Document No: 215-STT.00142
Dated Dec 08 2004 Job No.: 215
Attention: Mr. Lourdes David
Re: 04-0120R4
Temporary Bypass Structure

CC MYERS, INC.
JOB 215 TEMP. BYPASS STRUCTURE

Reference: Temporary Bypass Structure
Caltrans Contract #04-0120R4

Subject: Piping Routing and Design

Subject: REVISED PIPE SUPPORT @ K-RAIL
12" ± 4" WATER LINES

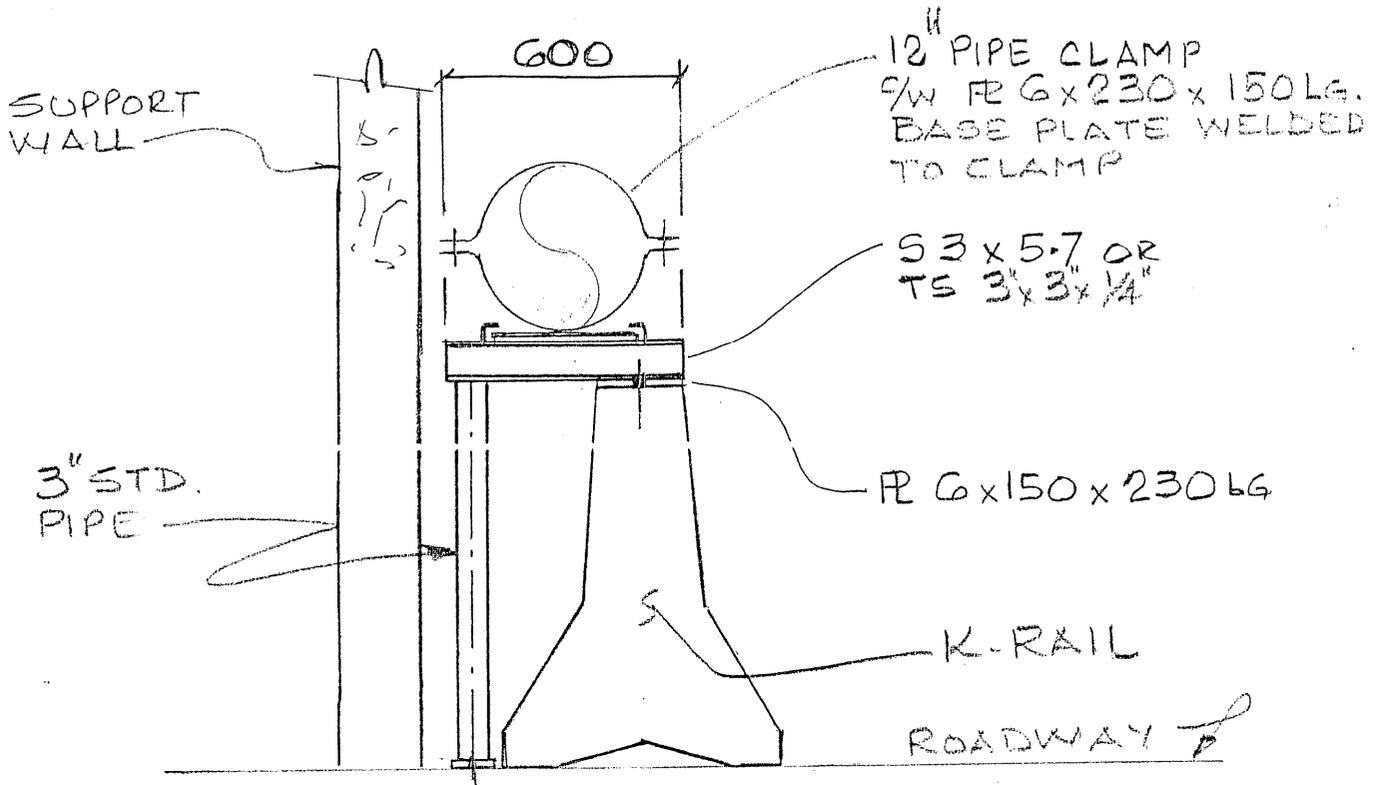
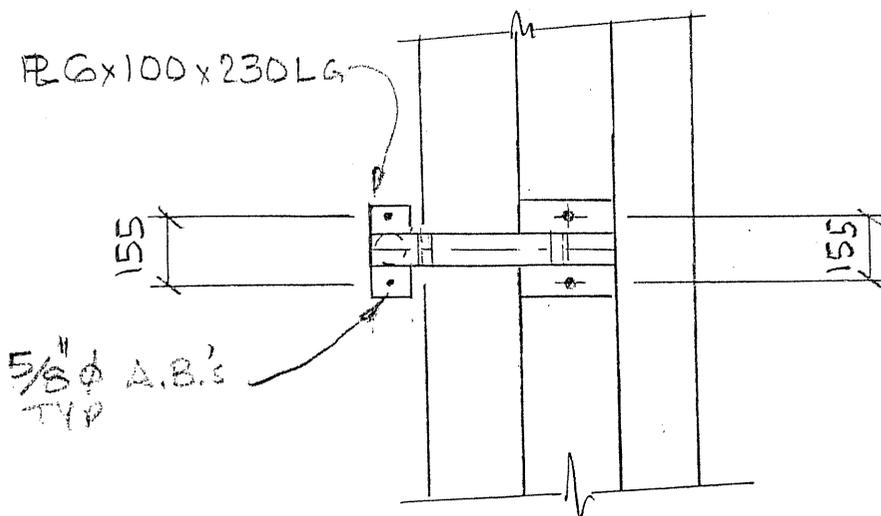
Fourthly, on the subject supporting the pipe of the K-rail, we concur that some eccentric loads applied to the K-rail could contribute to making less stable if it is not anchored to the deck. We believe that pipe supports could be designed to support the piping partly off the deck, behind the K-rail, instead of being attached solely to the K-rail. This would eliminate any eccentric loading to the K-rail. Please refer to the attached sketch showing this proposed method. Please advise if sufficient room exists there and we will redesign these supports accordingly. In conclusion, we firmly believe that our design meets all requirements of good engineering practice, the drawings and the specifications. This is the design we based our proposal on.

Alternately, we are prepared to redesign the supports for the K-rail portion of the routing as shown on the attached sketch at no additional costs. We propose you arrange a meeting with decision makers at Caltrans to discuss the benefits of our design and/or address any of their concerns.
